Office Action Summary

10/807,351

DETAILED ACTION***Claim Rejections - 35 USC § 103***

FIG. 3

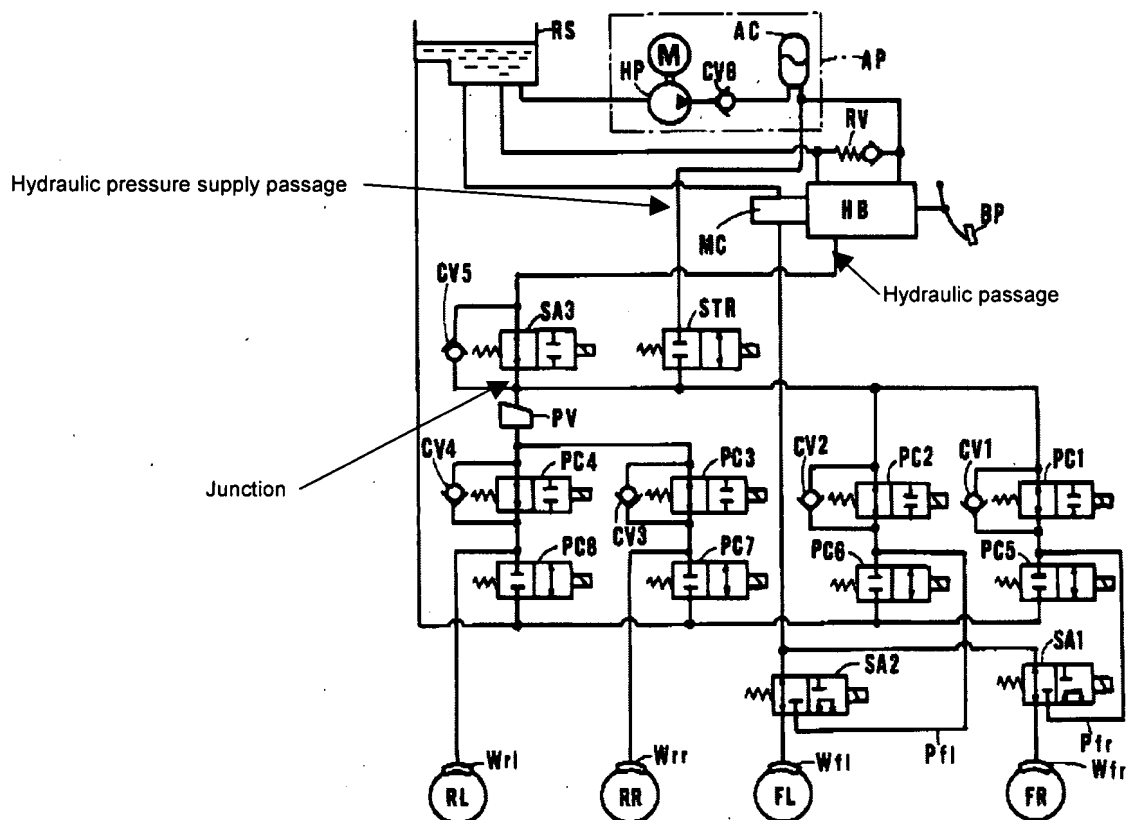
Re: claim 1. Tozu et al. show in figure 3 a vehicle hydraulic brake device comprising a hydraulic pressure source AP for generating and outputting a predetermined hydraulic pressure, a pressure adjusting valve HB,MC including a pressure adjusting mechanism for adjusting the output hydraulic pressure of the hydraulic pressure source to a value corresponding to a brake operating amount and wheel cylinders Wrl-Wfr actuated by the output hydraulic pressure of the pressure adjusting valve for imparting braking force to wheels of the vehicle, further comprising a hydraulic passage as labeled, a hydraulic pressure supply passage as labeled for supplying hydraulic pressure from the hydraulic pressure source to the hydraulic passage at a junction therewith, the hydraulic pressure supply passage by-passing the pressure adjusting mechanism of the pressure adjusting valve as shown, a first solenoid valve STR provided in the hydraulic pressure supply passage for reducing the output hydraulic pressure of the hydraulic pressure source and supplying it to the hydraulic passage leading from the pressure adjusting valve to the wheel cylinders, a second solenoid valve SA3 provided in the hydraulic passage at a location between the pressure adjusting valve and the junction and operable for reducing the output hydraulic pressure supplied from the hydraulic pressure supply passage, a check valve CV5 provided parallel to the second solenoid valve and allowing fluid flow from the pressure adjusting valve toward the hydraulic pressure supply passage and a controller ECU for controlling operations of the first and second solenoid valves, wherein control of the hydraulic pressure supplied to the wheel cylinders during automatic brake control is performed by operating the first solenoid valve to increase the hydraulic pressure in the

wheel cylinders as disclosed in col. 8 lines 36-50 and by operating the second valve to decrease the hydraulic pressure in the wheel cylinders as disclosed in col. 7 lines 48-53 and col. 7 line 66 – col. 8 line 2, and wherein when the output hydraulic pressure of the pressure adjusting valve exceeds the hydraulic pressure in the wheel cylinders in response to operation of the brake operating member during the automatic brake control, the output hydraulic pressure of the pressure adjusting valve is supplied into the wheel cylinders through the check valve as disclosed in col. 8 lines 5-10.

Tozu et al. are silent with regards to the first and second solenoid valves being proportional valves or specifically of the type in which a differential pressure between upstream hydraulic pressure and downstream hydraulic pressure thereof is controllable to a value corresponding to a control current applied thereto.

Peterson teaches in col. 19 lines 52-60 and in figure 17g the use of substituting a proportional valve 788 in place of a two-way solenoid valve 778,780.

It would have been obvious to one of ordinary skill in the art at the time the invention was made to have modified the two-way or two-position solenoid valves of Tozu et al. to have included proportional valves, as taught by Peterson, in order to provide a means of controlling the degree of opening of the valve to achieve a desired pressure differential.

Re: claims 2 and 3. See the rejection of claim 1 and, as shown in figure 3 of Tozu et al., a pressure chamber within the element labeled HB, a master cylinder MC inherently including a master piston actuated by the output pressure of the pressure adjusting valve introduced into the pressure chamber since, as broadly claimed, the

hydraulic pressure of the pressure adjusting valve is circulated throughout the brake device, a solenoid valve PC3 for supplying the output hydraulic pressure of the pressure adjusting valve to a hydraulic system leading from the master cylinder to the wheel cylinder Wrr, a hydraulic pressure supply passage as set forth above connected to a hydraulic passage as set forth above connecting the pressure adjusting valve to the solenoid valve. The hydraulic pressure source includes a power driven pump HP for producing hydraulic pressure and a pressure accumulator AC for accumulating hydraulic pressure produced by the pump.
